Service Information

Category P	Repair Guidance	Ref. No. R105/13	Page 1 of 2
Coverage <input type="checkbox"/> Distributor only <input checked="" type="checkbox"/> Please inform your dealers		Date Issued December 12 , 2013	
Please convey this information to your <input type="checkbox"/> Director <input checked="" type="checkbox"/> General Manager <input checked="" type="checkbox"/> Warranty Dept. <input checked="" type="checkbox"/> Parts Dept. <input checked="" type="checkbox"/> Training Dept. <input checked="" type="checkbox"/> Field Rep.		Date Revised	
Applicable Model Mazda6(GJ)		Applicable Countries or Specifications Europe

Subject: Front Brake Judder

BEGINNING VIN & DATE OF MODIFICATION

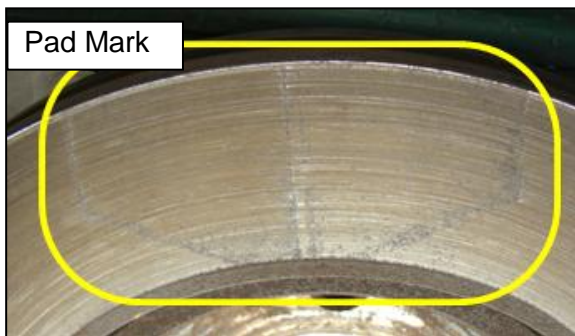
MASS PRODUCTION CHANGE

The material of front brake pad has been changed.

JMZ GJ** **** 158746

November 14, 2013

Initial pad mark

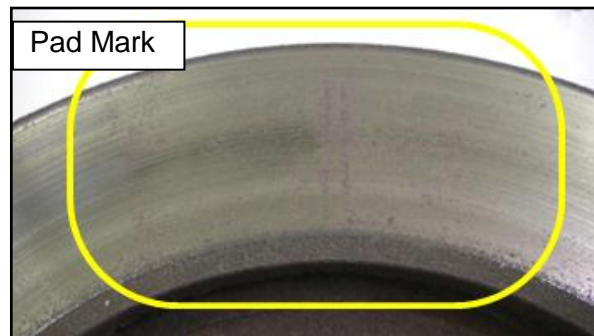
After being exposed to excessive heat generation, pad mark changes in its color.

Both pictures show pad marks

- (1) Measure the lateral runout of front disc plate according to the Workshop Manual.
If it exceeds the limit, machine the disc plate using an on-the-car type lathe and adjust the disc thickness to within the limit.
- Front disc plate runout limit: 0.04mm (at the axial position of 10 mm from the disc plate edge)
 - Minimum front disc plate thickness after machining using a brake lathe on-vehicle: 26.8 mm
- (2) Replace the front brake pads with modified ones according to the Workshop Manual procedure.

Caution: DO NOT use an off-the-car type lathe because it causes the disc plate runout to increase.
